Prairie Island Nuclear Generating Plant Units 1 and 2
Dockets 50-282 and 50-306
License Nos. DPR-42 and DPR-60

Supplement to License Amendment Request for Measurement Uncertainty Recapture – Power Uprate – Response to Requests for Additional Information (TAC Nos. ME3015 and ME3016)

Response to NRC Requests for Additional Information, dated March 17, 2010, Regarding a License Amendment Request for a Measurement Uncertainty Recapture Power Uprate Project at the Prairie Island Nuclear Generating Plant

Generator Capacity Curves – Units 1 and 2

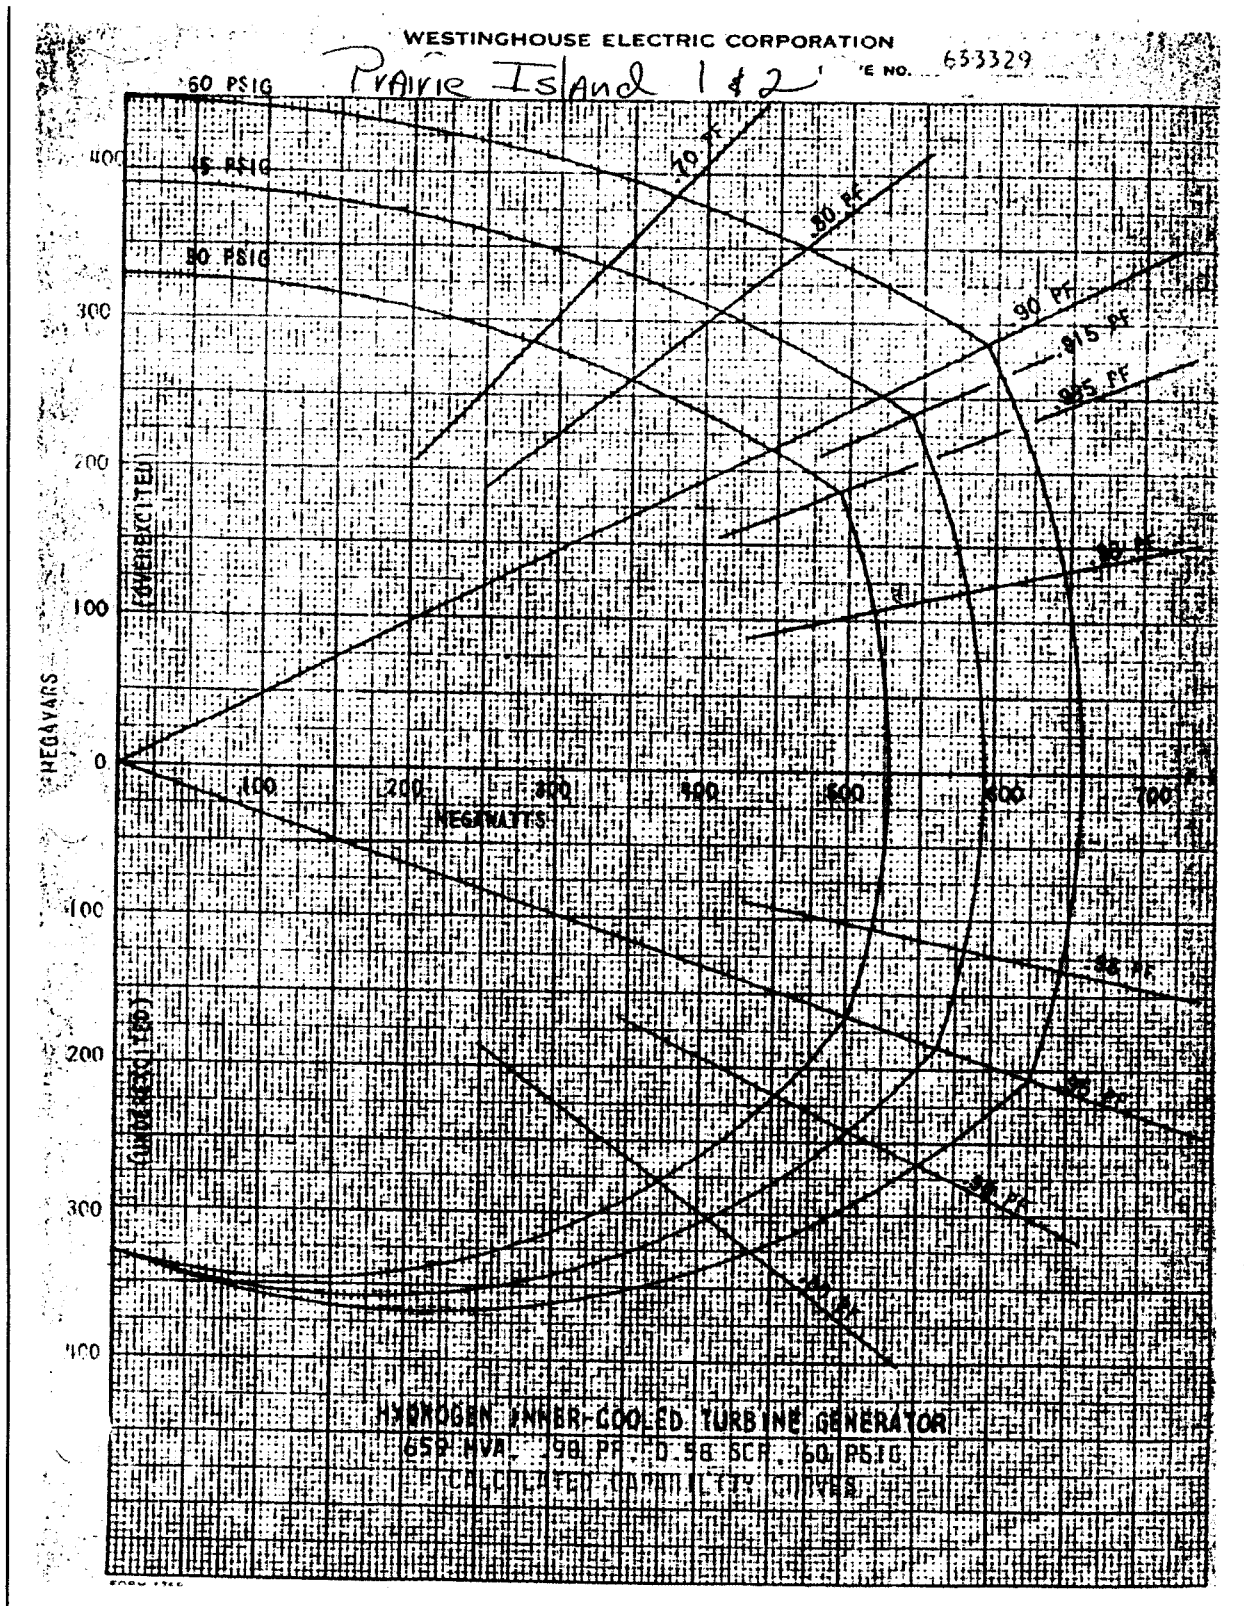
Provide more detailed discussion of the uprated loadings for each of the main generators with respect to their nameplate ratings. Also, provide the nameplate ratings and the uprated loadings of the generator step up transformers, plant service transformers and the main generator isolated phase bus.

The generator capability curve for both Unit 1 and Unit 2 main generators is attached.

USAR Section 1.1.1 states that each reactor is capable of a gross electrical output of 575 MWe. The MUR power uprate will add approximately 9 MWe, depending on house load sharing, for a post-uprate gross electrical output of 584 MWe. This output is conservatively below the generator capabilities of approximately 592 MWe.

The isolated phase bus duct transmits power from the generator terminals to the generator step-up (GSU) transformer. The bus is rated at 20,000 amps. This rating fully supports the generator capability curve over the full range of generator voltage. Since there is no proposed change to the generator capability curve for MUR power uprate, there is no impact on the design duty for the isolated phase bus duct due to the MUR power uprate, and the isolated phase bus duct is acceptable for MUR power uprate operation.

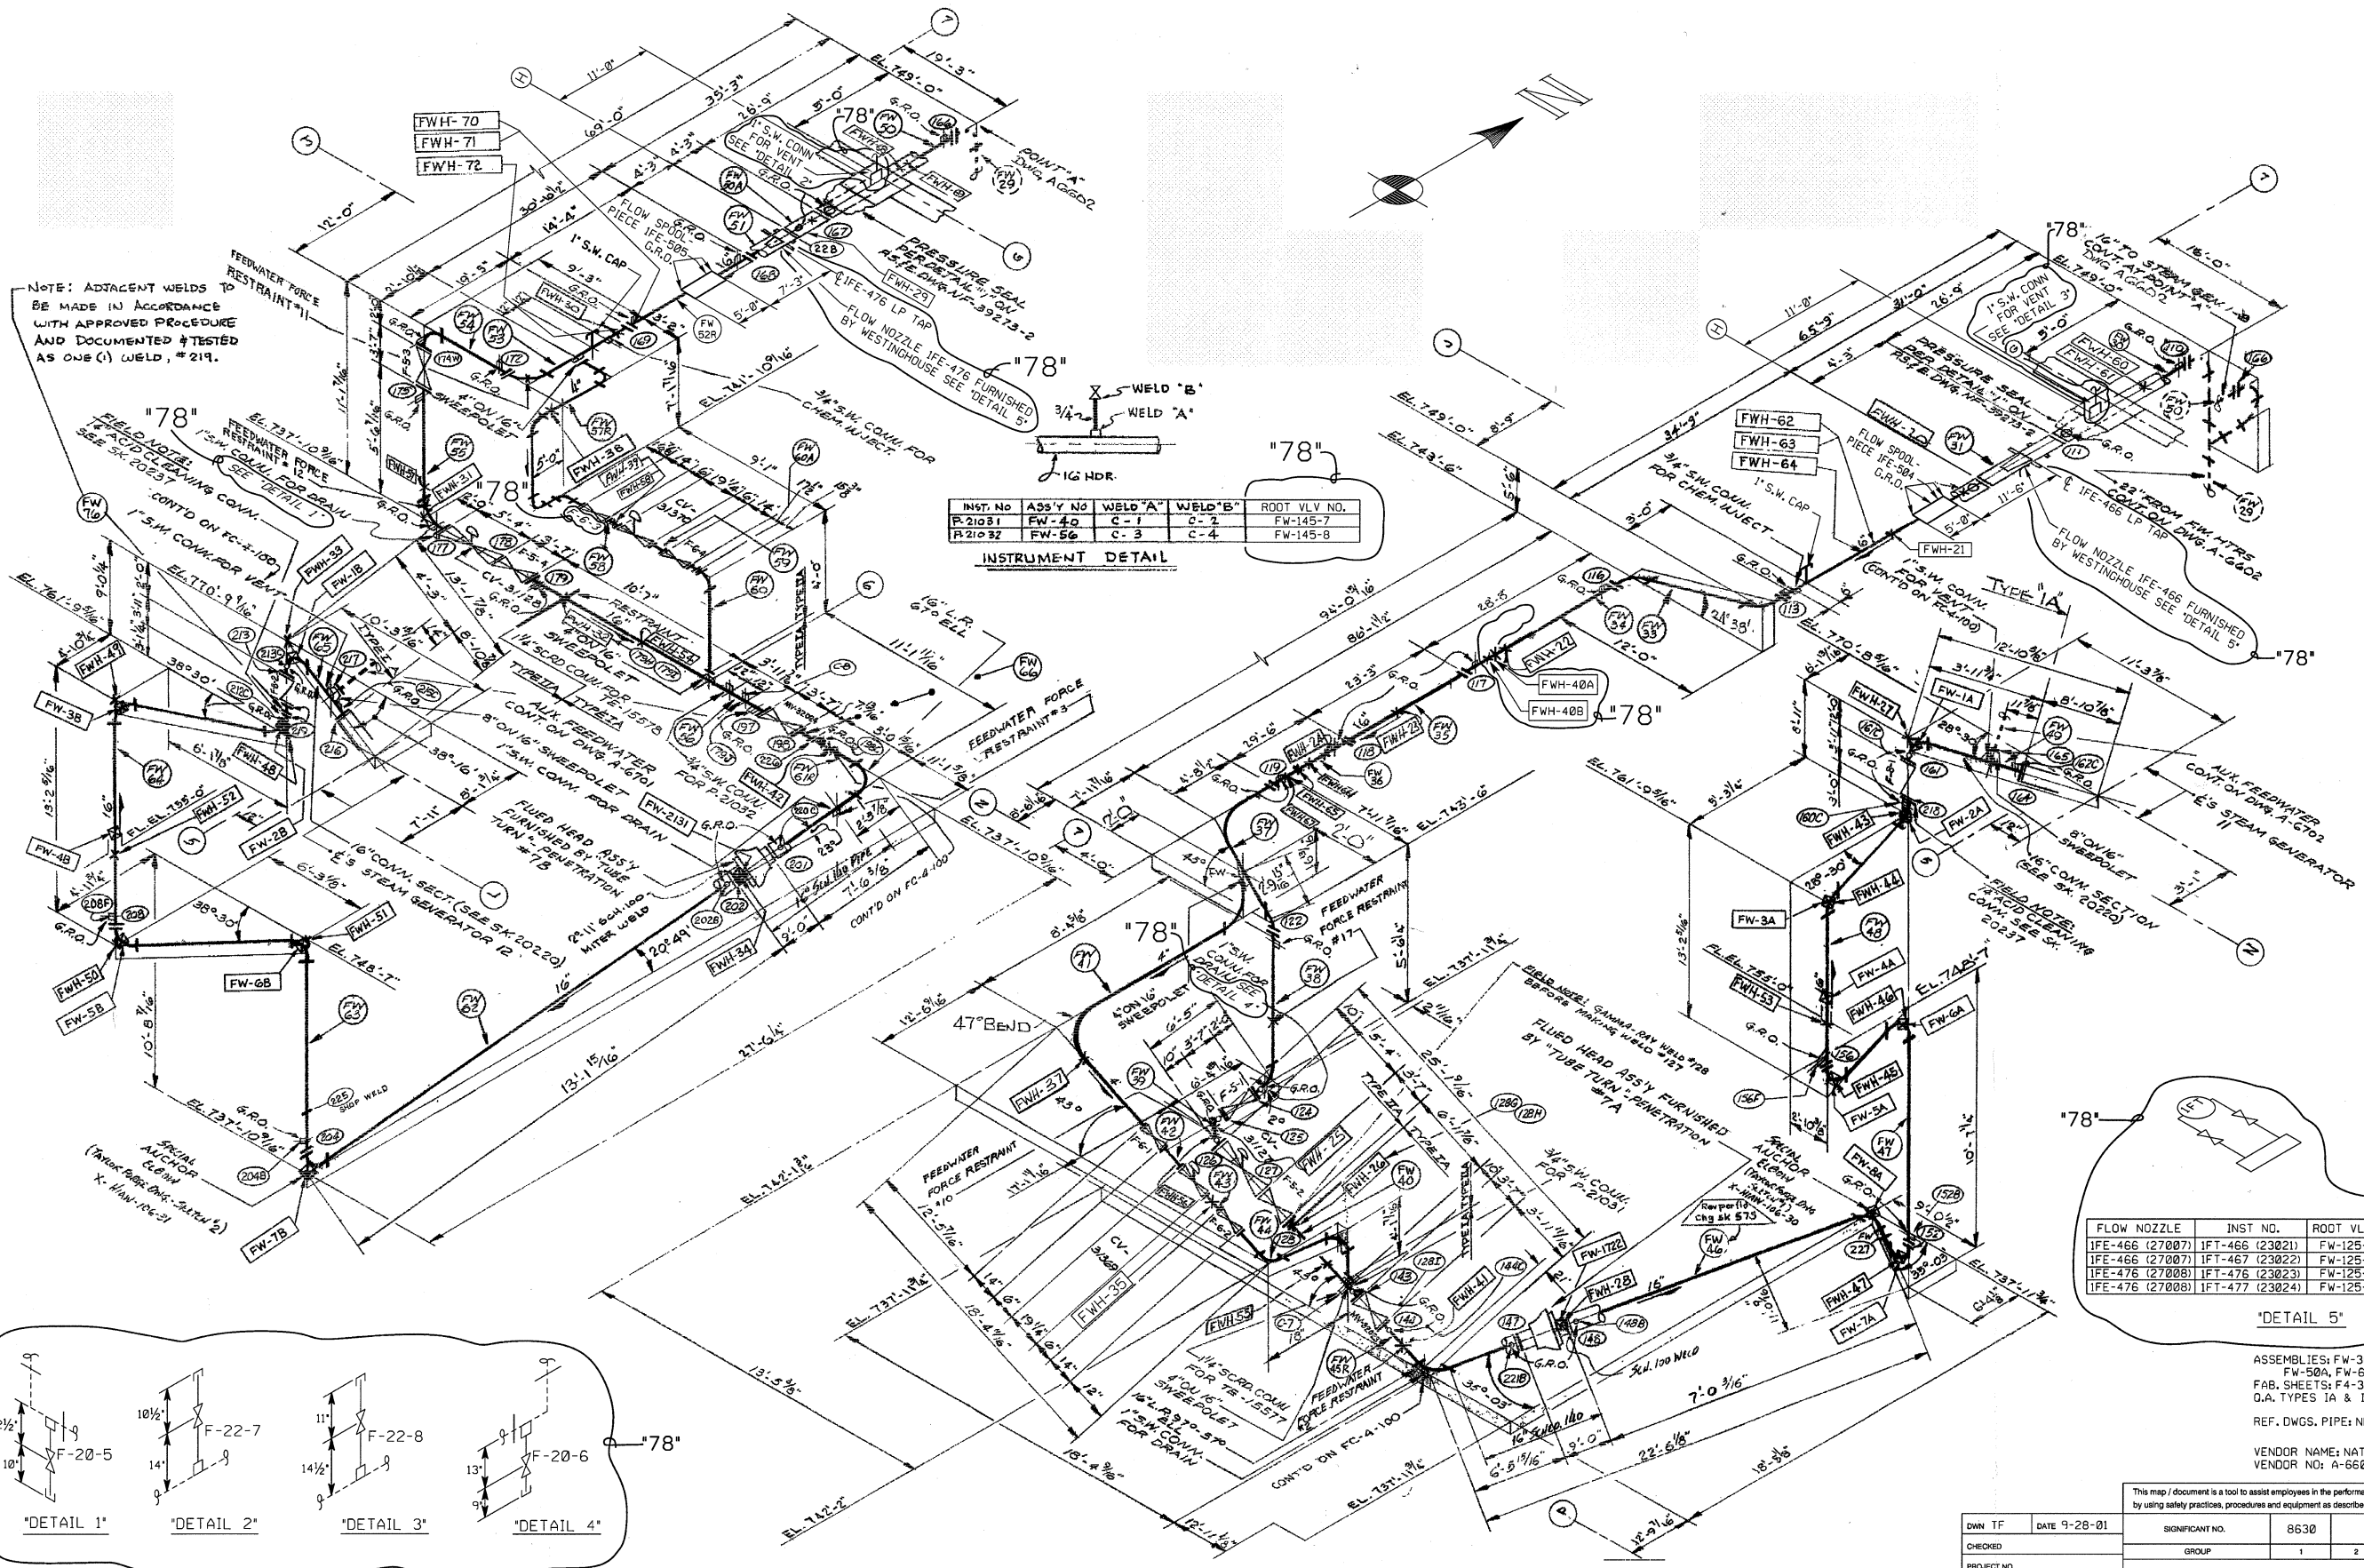
Describe and provide drawings of the location where the unified field mechanics [UFMs, ultrasonic flow meters] are installed. The information should be sufficient for the NRC staff to perform an in-depth comparison of the Alden Labs test configuration with the in-plant configuration.

- PINGP Unit 1 Feedwater piping isometric drawing XH-106-130, Revision 78, which shows the as-built location of the LEFM flow meters and venturi flow nozzles
- PINGP Unit 2 Feedwater piping isometric drawing XH-1106-246, Revision 77, which shows the as-built location of the LEFM flow meters and venturi flow nozzles
